**Flood Control Project Maintenance
Levee Inspections**
LMA District Cover Sheet
Spring 2017 Levee Inspection Results

Butte County Department of Public Works

Levee Inspection Report By Mile - Spring 2017

Waterway	Bank	Unit Miles	Inspection Start/End	Inspector
Unit No. 01 Mud Creek	Right	6.80	04/20/2017 04/20/2017	Bob Duffey

Photo 1 of 1 : SP_2017_NA0003_64_53_20170315_00032.jpg

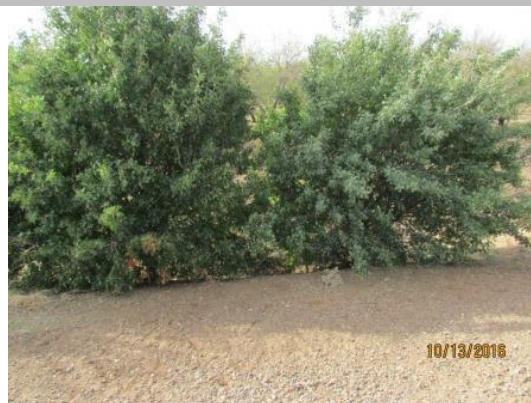
LM Start	4.45	Rating **	M	Issue No.	53
LM End	4.45	Issue Type +	Ma	Location *	LS
Category	Earthen Levee			GPS Latitude/Longitude	
				Start	End
Item	Trim / Thin Trees			39.775789 °	39.775789 °
				-121.894048 °	-121.894048 °
DWR ID	DWR_NA0003_01_f_2016_53				
Comment Code					
T1 : Trim trees to at least five feet above ground level.					
Inspector Comment

View of the trees along the landside toe.

Photo 1 of 2 : UCIP_SP_2017_30388_55891.jpg

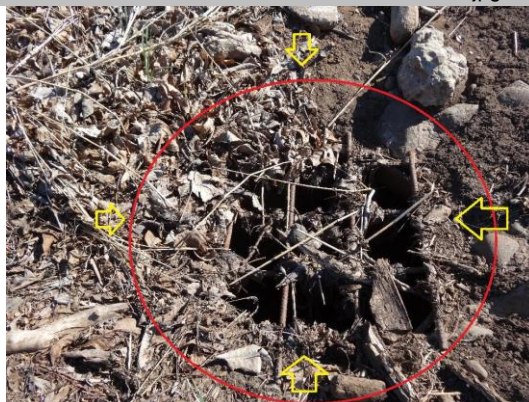
Comment Code					
Inspector Comment					
FS_ID:30388					
DS_ID:19221					
EP_NO: N/A					
Repair Type: Non-Urgent					
Crossing Status: Found					
UCIP Comments: CM Standpipe intake. Intake pipe with air vent. Steel rib-bar grit cover on the standpipe on landside levee toe.Needs cleaning and clearing on both ends of the pipe.					
FIELD_STRUCT_DESC: 24-inch CM pipe through the levee, 15.0 feet below the crown. Flap gate on the waterward end. Concrete "U" headwalls on waterside ends. Grouted riprap spillway on the waterward end. CM Standpipe intake. Intake pipe with air vent. Steel rib-bar grit cover on the standpipe on landside levee toe. O&M Manual Sac 504, May 1965.					
FS Date: 2/20/2014

WS view: U type concrete headwall, pipe, and flapgate on levee slope. Vegetation/soil debris blocking outlet.

Photo 1 of 2 : UCIP_SP_2017_31129_57036.jpg

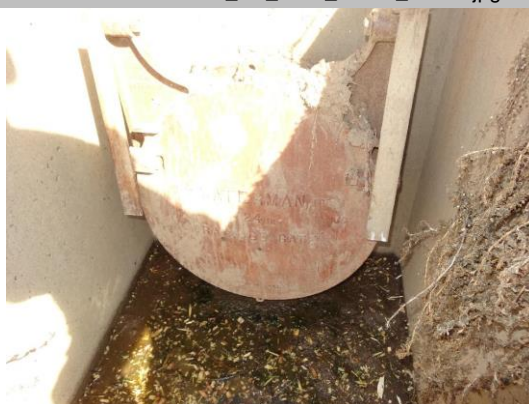
LM Start	7.77	Rating **	M	Issue No.	59
LM End	7.77	Issue Type +	Ma	Location *	LS
Category	Supplemental			GPS Latitude/Longitude	
				Start	End
Item	DWR UCIP LMA Responsibility			39.711436 °	39.711436 °
				-121.937135 °	-121.937135 °
DWR ID					
Comment Code					
Inspector Comment					
FS_ID:31129					
DS_ID:19254					
EP_NO: N/A					
Repair Type: Non-Urgent					
Crossing Status: Found					
UCIP Comments: Debris in inlet pipe, needs cleaning and clearing.					
FIELD_STRUCT_DESC: 24-inch CM pipe through the levee, 18.0 feet below the crown. Flap gate on the waterward end. Concrete "U" headwalls on both ends. Grouted riprap apron on the landward end. Grouted riprap spillway on the waterward end. O&M Manual Sac 504, May 1965.					
FS Date: 2/25/2014

WS view: U type concrete headwall, pipe, and flapgate on levee slope. Soil/mud on outlet box.

Photo 1 of 2 : SP_2017_NA0003_69_3_20170426_00010.jpg

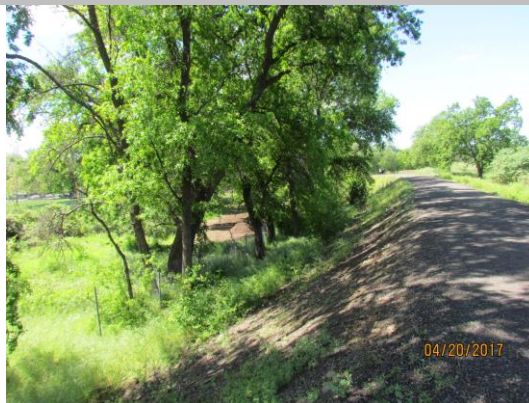
LM Start	0.34	Rating **	M	Issue No.	3
LM End	0.42	Issue Type +	Ma	Location *	LS
Category	Earthen Levee			GPS Latitude/Longitude	
				Start	End
Item	Vegetation			39.761633 °	39.761117 °
				-121.795155 °	-121.796464 °
DWR ID	DWR_NA0003_05_f_2013_3				
Comment Code					
V2 : Remove the wild growth other than native grasses from the levee slopes.					
Inspector Comment

View of the vegetation along the landside slope and toe.
